November 11, 2016

**University College Revitalization (Revised Phase 1) and Croft Chapter House  
(Phase 2): Additional Project Scope**

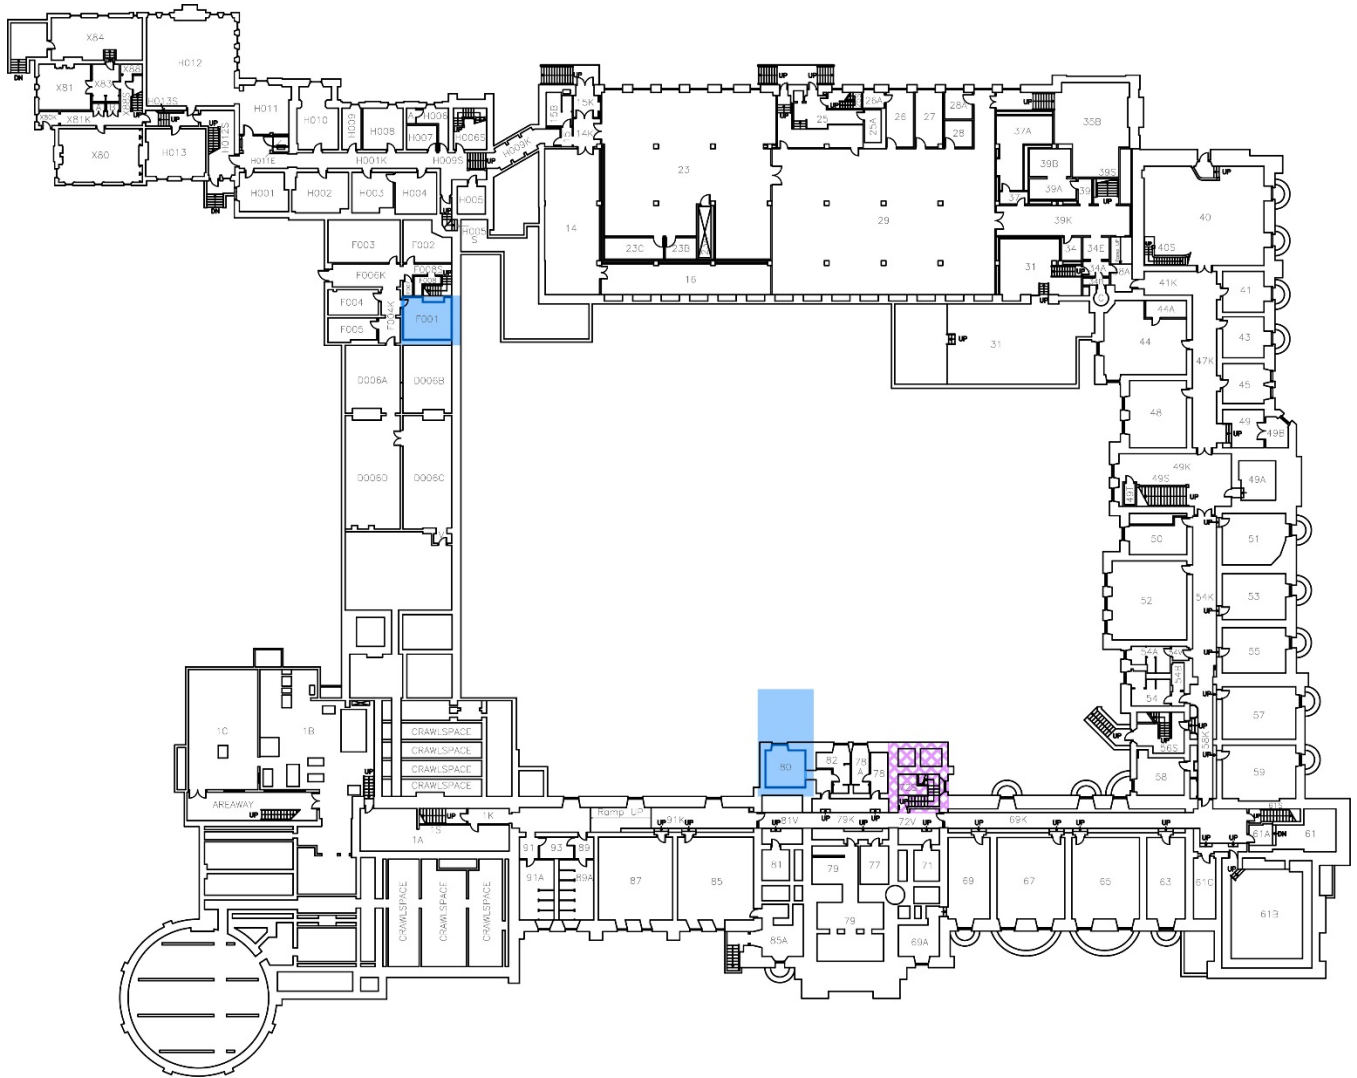
d) **Design resolution of Secondary Effects to these changes in project scope** (+110nasm) (179 gsm). Secondary Effects resulting from the new proposed location of the elevator include providing access routes, accessibility, as well as the removal of rooms, as follows:

- The relocation and renovation of a Janitor's office & lunchroom from UC 80 to UC F001 (18.3 nasm)
- The renovation of UC 375 as a Faculty office from UC 272 (18.6 nasm)
- The relocation of the mail room UC 172 to the existing CAO office UC 158 (17.4 nasm) and the subsequent relocation of the CAO's office to UC 171 / 171A, with a new connection through to UC 173 (19.3 nasm).
- The conversion of UC 371 & UC 373 to the Librarian's office (22.8 nasm)
- The conversion of UC 377 to a universal washroom (13.6 nasm)

# University College Basement Floor Plan

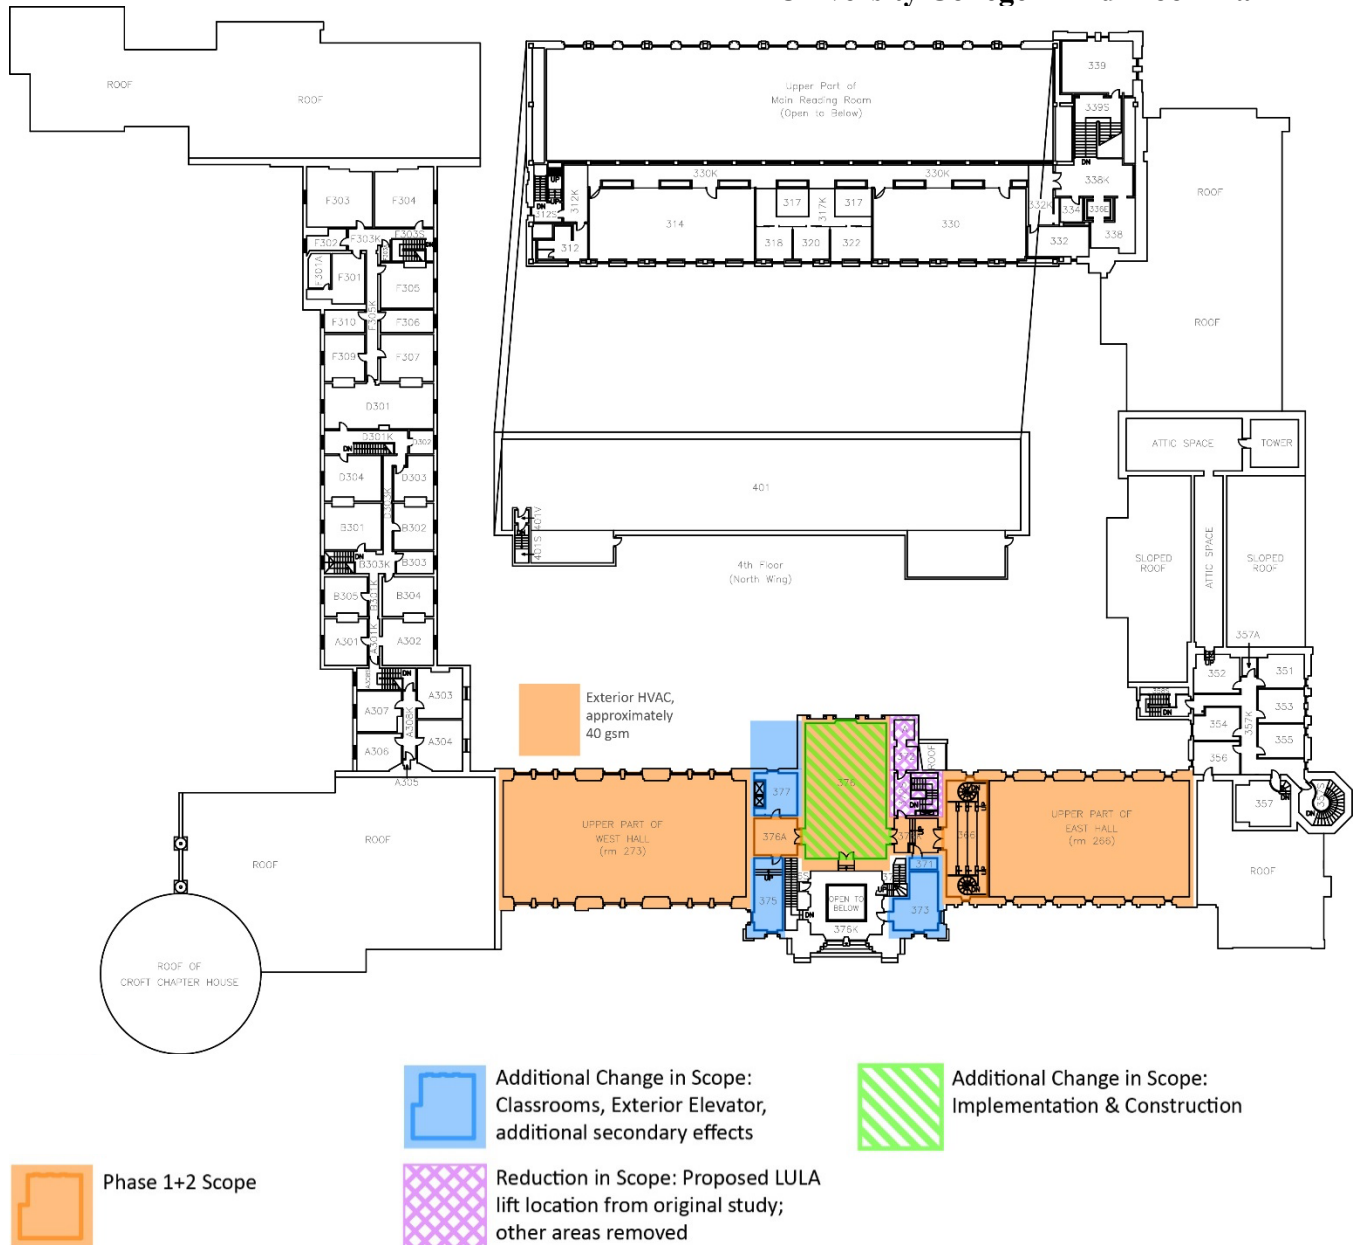
Additional Change in Scope: Full Service Elevator, related secondary effects

Reduction in Scope: Proposed LULA lift location from original study; remove from scope of work

- New full service elevator in area of Room 80 (existing Janitor lounge)
- New relocated Janitor’s lounge in F001
- Removal of LULA area from scope
